**Before the Regulation Hearing Committee appointed
by Canterbury Regional Council**

IN THE MATTER OF Application CRC051792 by
Messrs A G & P G Wilson for a
discharge permit to discharge
contaminants to land.

Section 42A Officer's Report

Report of Amy McEwan and Jacqui Todd

Figure 4. HSFW Specifications

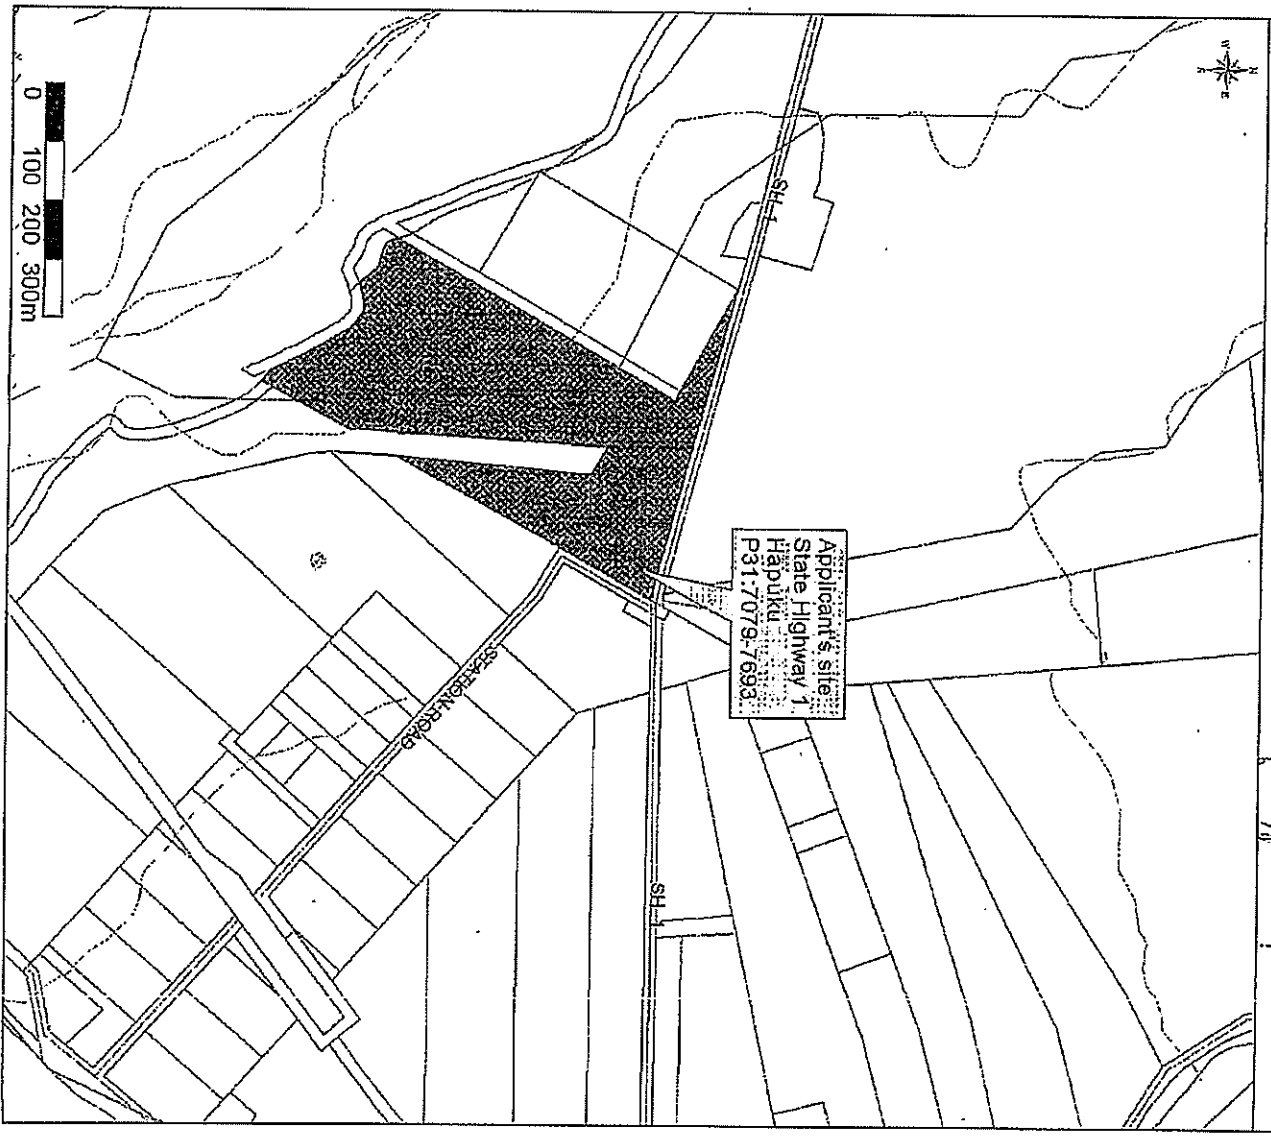
- (d) Physical filtering of suspended solids.
 - (e) pH buffering.
36. The specifications of the wetland are shown on Plan CRC051792D (Appendix 2).

71. The applicant has stated that as the horizontal subsurface wetland proposed uses subsurface flow, there will be no exposed wastewater on the surface. They have provided a cross section plan of the wetland (attached to the conditions as Plan CRC051792D) which shows that the wetland will contain a series of coarse gravels, gravel and coarse sand within an impermeable lining that the wastewater will flow through.

72. In addition, Golder's wastewater engineer has checked the capacity of the wetland and agrees that it will have capacity for the maximum wastewater volume.

- (7) The horizontal subsurface wetland shall:
 - (a) have a minimum surface area of 336 square metres;
 - (b) have a minimum depth of sand/gravel of 0.5 metres;

- (c) have a minimum width of 25 metres; and
 - (d) be constructed in accordance with Plan CRC051792D.
- (8) The wastewater shall be discharged via a land application system as follows:

Plan CRC051792C

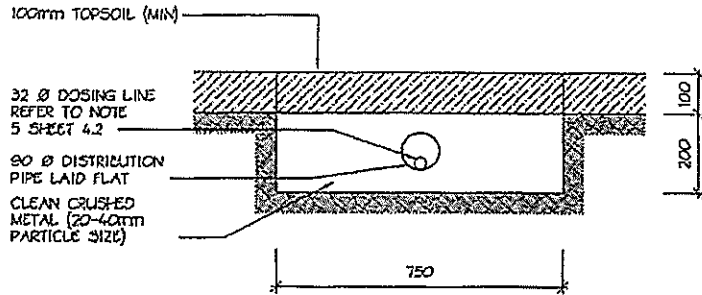
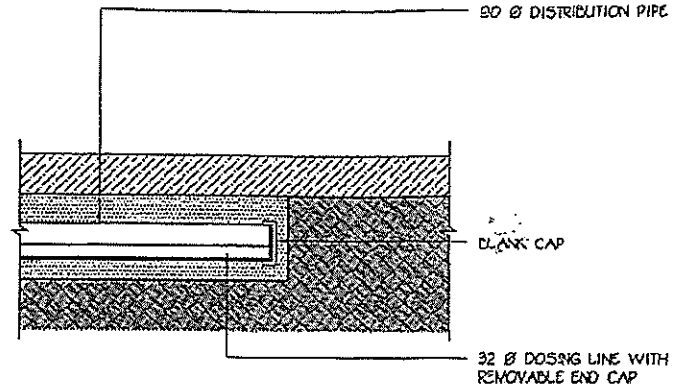
- (a) The trenches will be installed with the base being 300 millimetres (mm) below ground level, as shown on Plan CRC051792C (Appendix 2).
 - (b) The trenches will contain 100 mm of topsoil and 200 mm of crushed metal.

- (c) The wastewater will discharge into the crushed metal layer via a low pressure distribution pipe.
 - (d) The land application system will be located 37 m from the northern property boundary and 18 m from the eastern property boundary.
